STAFF REPORT  
KETCHUM PLANNING AND ZONING COMMISSION  
MEETING OF JUNE 11, 2024

**PROJECT:** Baldy Mountain House

**FILE NUMBER:** P24-021

**APPLICATION:** Pre-Application Design Review

Figure 6: Baldy Mountain House Pedestrian Circulation

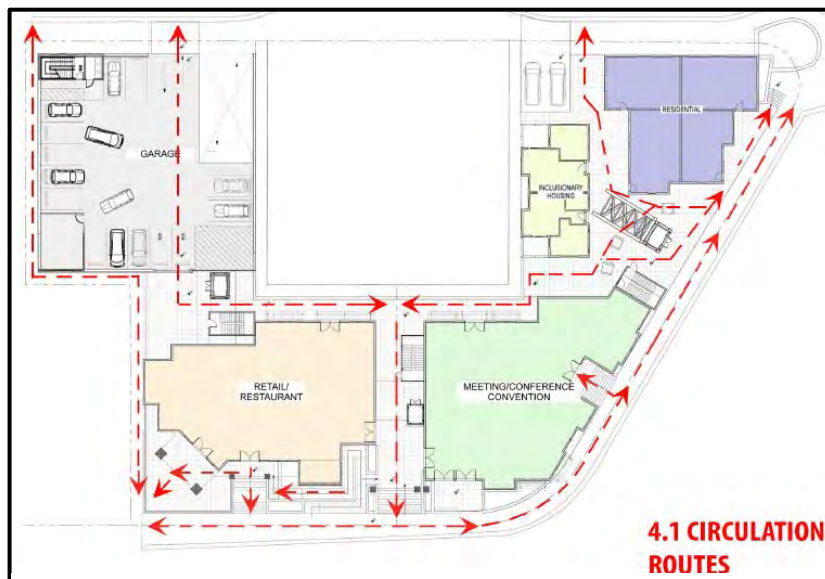
As described and shown (see Figure 6) on page 4 of the applicant’s narrative response to the WSBA Village Design Guidelines (see Attachment A4), multiple pedestrian pathways are proposed, however the raised terrace blocks access from the Aspenwood Condominiums through the site to Picabo Street and Warm Springs Lodge. Staff recommends the applicant consider providing a pedestrian pathway through the development from Aspenwood Condominiums directly to Picabo Street.
